**RE: *Item 10.2 – October 20, 2020 City Council Agenda:
C19-013, CP19-013 and T20-015 – Conforming Rezoning, Conditional Use Permit,
and Tentative Map for Certain Real Property Located at 550-570 Meridian Avenue,
1401 Parkmoor Avenue, and 529, 592, and 691 Race Street***

San Jose Vasona Quiet Zone Diagnostic Review Comments & Responses

DATE: August 6, 2019 (Day 1)

LEIGH AVE

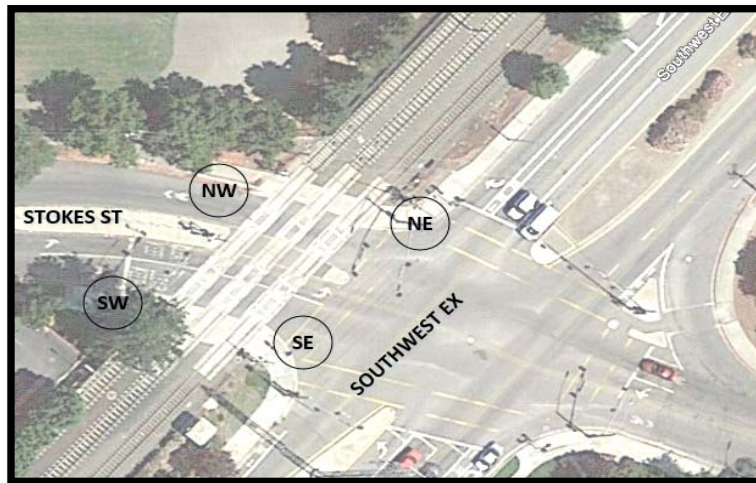
<i>SW quadrant (where Cheney intersects Leigh)</i>	
<p>4 On Cheney Dr, update W10-9P and place under W10-4; add W48 CA (3 Tracks) under W10-4; rotate W10-4 (Immediate action item)</p>	<p>See proposed signage and striping plans in Attachment K. These changes are reflected.</p>
<p>5 Remove W10-1 (since W10-4 is the appropriate sign here) (Immediate action item)</p>	<p>See proposed signage and striping plans in Attachment K. This sign will be removed.</p>
<p>6 Update W10-9Ps mounted on streetlight poles at crossing and at RXR pavement marking to standard size</p>	<p>See proposed signage and striping plans in Attachment K. These changes are reflected.</p>

7	Check striping; stop bar at Cheney Dr should be intersection type; also need crosswalks at Cheney	See proposed signage and striping plans in Attachment K. Cheney Dr is converted from Yield to Stop control; the triangle island is removed; the south corner is bulbed out; a crosswalk is added across Cheney.
8	The automated pedestrian gate is mounted on the same pole as the vehicle gate; this is no longer allowed because if someone were to lift up one gate, the other gate would also lift up; this would have to be upgraded to the current standard if this crossing's electrical devices were modified	n/a - informational comment
9	There are advance warning signs (Look both Ways, No Train Horn, Look) mounted on a pole inside the crossing; relocate to be in advance of the crossing so they can warn users in advance; consider mounting on pedestrian swing gate	See proposed signage and striping plans in Attachment K. These signs will be relocated.

<i>SE quadrant</i>		
10	Check warning sign sizes	The R15-8 sign will be removed. The W82-1(CA) and W10-9P signs conform to CA MUTCD size requirements.
11	Ideally this quadrant would have the same pedestrian treatments as those on the other side of the tracks (Commission Standard #9 pedestrian gate EXIT, swing gate, channelization)	VTA plans to install pedestrian gates on this quadrant as part of the "Pedestrian Back Gates" project. This work will include relocation of the detectable warning strips.
12	Check that the detectable warning strip is a safe enough distance from the UPRR track	See Leigh Comment Response #11.
13	If this crossing's electrical system was modified, the "No Right Turn" dynamic display sign would need to be updated to the current R3-1 Activated Blank Out Sign standard	n/a - informational comment
14	Signs are not compliant with GO 26-D clearance requirements. Signs need to be relocated	See proposed signage and striping plans in Attachment K. These signs will be relocated.

<i>NE quadrant</i>		
15	If this crossing's electrical system was modified, the "No Right Turn" dynamic display sign would need to be updated to the current R3-1 Activated Blank Out Sign standard	n/a - informational comment
16	Check the pedestrian signal at the north end of the crosswalk across Leigh; the countdown did not appear with one of the pedestrian phases (immediate action item)	This occurred because the Ped Walk and Ped Clearance phases are terminated when preemption is initiated per CA MUTCD standard 4D.27.29. The pedestrian phase returns to normal in the next cycle after the train has cleared.
17	Consolidate the W10-9P and W10-4 signs; add a W48(CA) sign	See proposed signage and striping plans in Attachment K. These signs will be consolidated.
18	For clearance, relocate the advance warning signs which are currently located between the UP track and the gate arm	See proposed signage and striping plans in Attachment K. These signs will be relocated.

19	Ideally there would be better pedestrian accommodation, including a wider refuge area here, pedestrian gates, and a wider paved area crossing the tracks. Requires major reconfiguration including relocating Commission Standard #9 pedestrian gate, install EXIT swing gates, install channelization behind relocated #9 vehicular gate.	With VTA's Pedestrian Back Gates project, this crossing will have pedestrian treatments on three out of four quadrants. This would be the only remaining quadrant without pedestrian treatment. The vehicle gate currently encompasses the entire sidewalk. Relocating the vehicle gate and/or adding pedestrian treatments was not prioritized at this location.
<i>NW quadrant</i>		
20	For southbound (or westbound) Leigh, adjust far-side louvers so that drivers at the pre-signal cannot see the green light at the downstream signal	See proposed signage and striping plans in Attachment K. The stop bar will be relocated and signal heads will be evaluated.

21	Signal box blocks visibility between trains and sidewalk; ideally it would not have been placed here	The general comment that signal box location is important as it relates to visibility between the crossing and the rail corridor is noted and will be considered in design of new crossings and redesign of existing crossings.
22	There is a space between the signal box and the fence behind it; shrubbery obstructs view of it; this space should be maintained and monitored to prevent criminal activity or tampering with the crossing	Comment for VTA.
23	Trim the tree behind the signal box	Comment for VTA.
24	There is a No Trespassing sign on the fence behind the signal box; trim the foliage blocking the sign and also consider relocating the sign	Comment for VTA.
25	Remove the non-compliant No Train Horn sign and pole; there is already a (compliant) No Train Horn sign within 10 feet of it	See proposed signage and striping plans in Attachment K. This sign will be removed.

26	Relocate the bus stop which is located about 90 feet west of the crossing; stopped buses can cause vehicles to queue over the tracks	VTA removed this bus line in December 2019 as part of a new transit service place.

BASCOM STATION-NORTH & BASCOM STATION-SOUTH

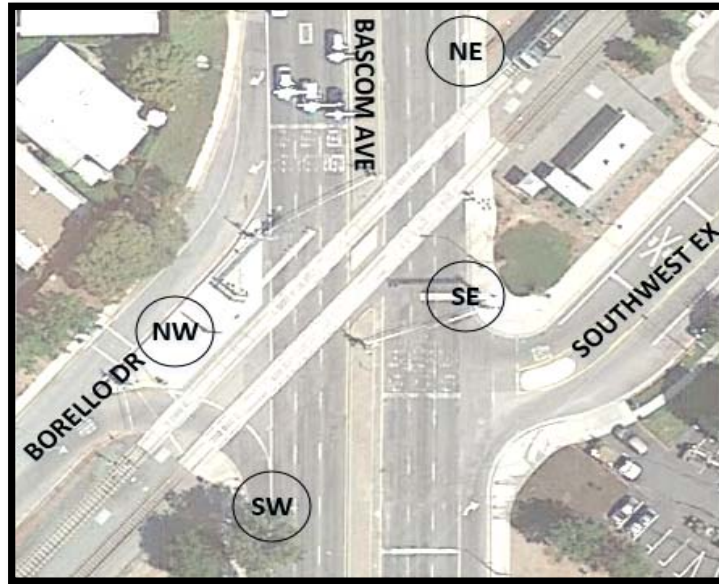
4 Consider standard sign set up at all station crossings; perhaps move "Look Both Ways" and "No Train Horn" signs to swing gates	City is currently coordinating signage and striping plans with VTA.
5 Crossbuck signs on posts need to be rotated to face pedestrians coming from outside the crossing- rotate or add another crossbuck sign facing the nearest approach	Comment for VTA.
6 Replace signs damaged with graffiti (immediate action item)	Comment for VTA.
7 Swing gates need maintenance (immediate action item)	Comment for VTA.
8 Striping across tracks to delineate edge of pedestrian path needs to be refreshed	Comment for VTA.
9 Relocate detectable warning strips to outside of crossing	Comment for VTA.

10 Future development on the west side of the rail corridor will need See Bascom Stations Comment #3.
a Commission Standard #8 flasher on west side of tracks

11 Blue ENS should be relocated to the post with the crossbucks as is
typical at other ped crossings Comment for VTA.

12 There is a "Look Both Ways" sign in between the tracks; consider
removing, or relocate to swing gate Comment for VTA.
